**APPLICABILITY:** 2024-25MY Crosstrek

**NUMBER:** 12-270-25

**SUBJECT:** Tailgate Side Inner Trim – Design Change

**DATE:** 09/30/25

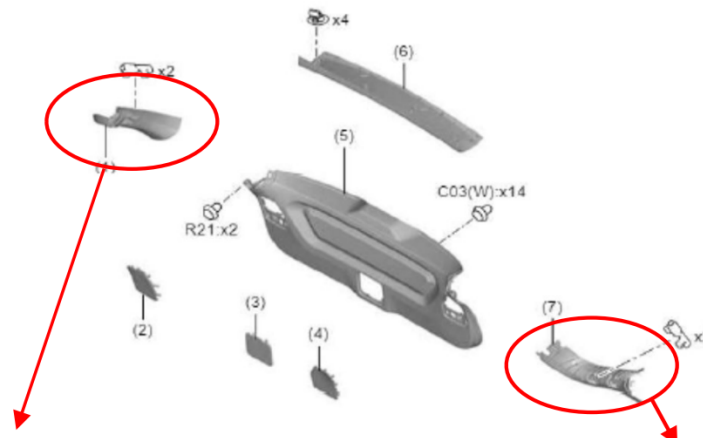
This bulletin announces design changes to both the right and left rear gate inner side trim panels, as shown in the image below. The new design enhances the durability of the trim panels and helps prevent potential damage during removal or reinstallation.
